Foothills Medical Centre Power Plant Expansion Project

Alberta Utilities Commission

Decision 23958-D01-2020

Foothills Medical Centre Power Plant Expansion Project

Figure 1. Map of noise receptors

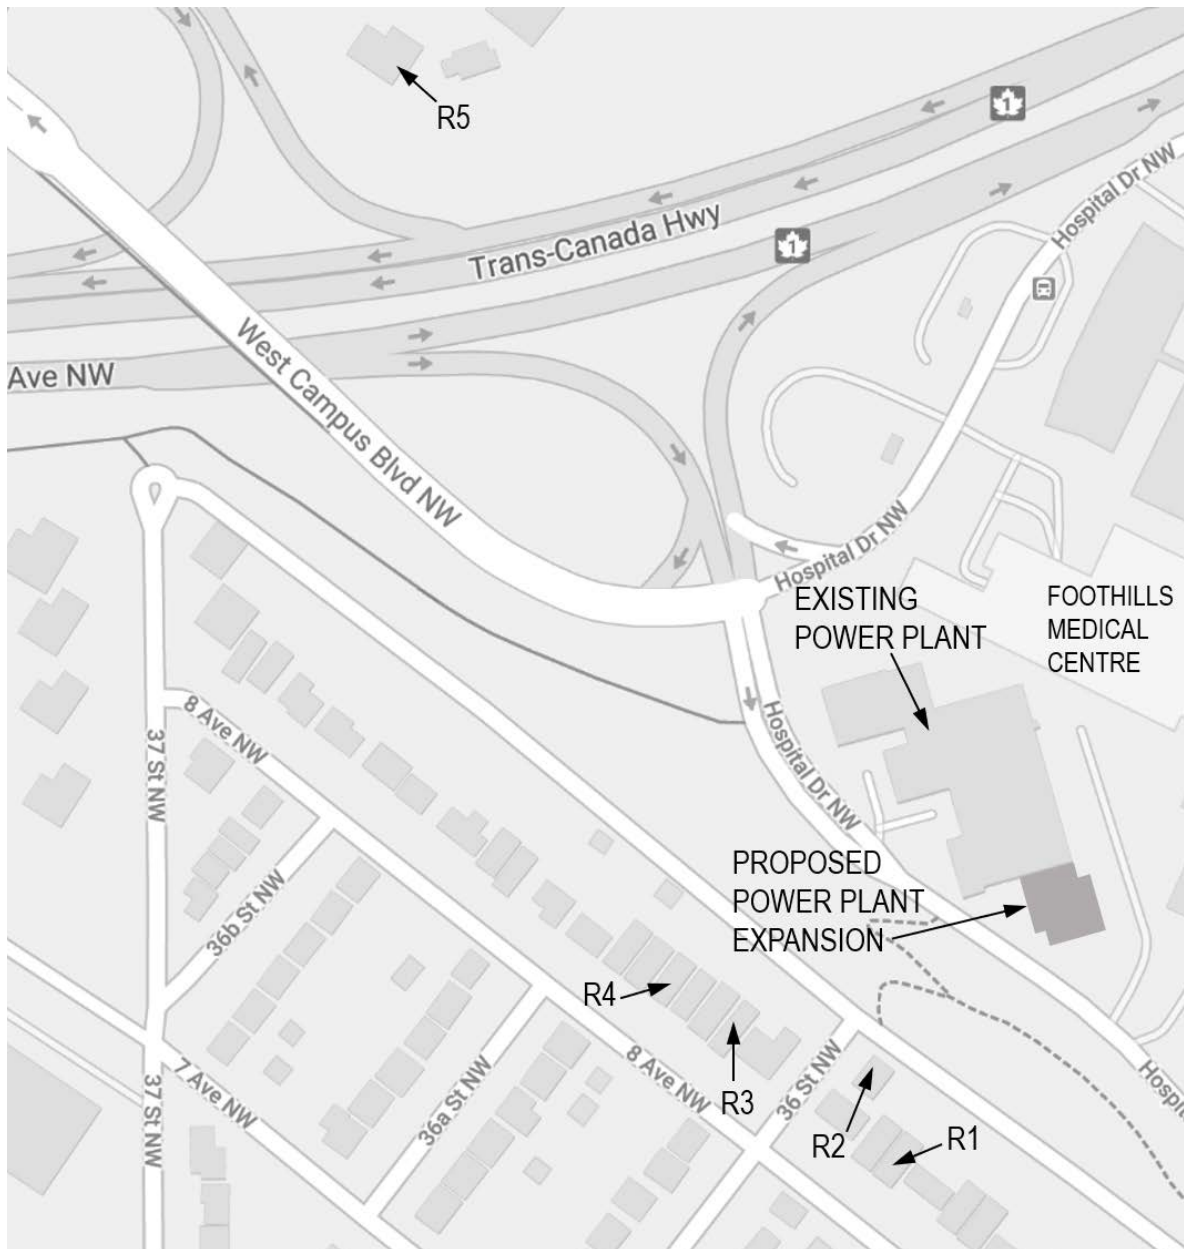
17. The project NIA included five dwellings as noise receptors, presented in Figure 1 below. Four of the receptors (R1, R2, R3, R4) are located in the community of Parkdale. The fifth receptor (R5) is located in the community of University Heights. The distances of each of the five receptors from the project are as follows:

36. However, as stated earlier, deferred facility status was eliminated on October 17, 2018, and a more stringent nighttime PSL of 51 dBA is now applicable to the FMC Power Plant. AI conducted an exhaustive mitigation study at the noise prediction stage. In the next section of this decision, the Commission directs AI to implement certain mitigation measures before the project commences operations. However, as shown in Table 5 below, despite the implementation of those measures, predicted cumulative sound levels at receptors R1, R2, R3, and R4 nonetheless exceed the nighttime PSL of 51 dBA by up to 1.1 dB.

80. The Commission finds that receptors R1, R2, R3 and R4 would be appropriate for the post-construction CSL survey because (i) these receptors are the closest dwellings to the FMC Power Plant, (ii) the predicted cumulative sound levels at these receptors exceed the nighttime PSL of 51 dBA, (iii) the predicted noise contribution from the expanded FMC Power Plant at these receptors is greater than the assumed nighttime ASL of 46 dBA (which means the FMC Power Plant is a major noise contributor at these receptors), and (iv) selection of these receptors is consistent with AI's recommendation.
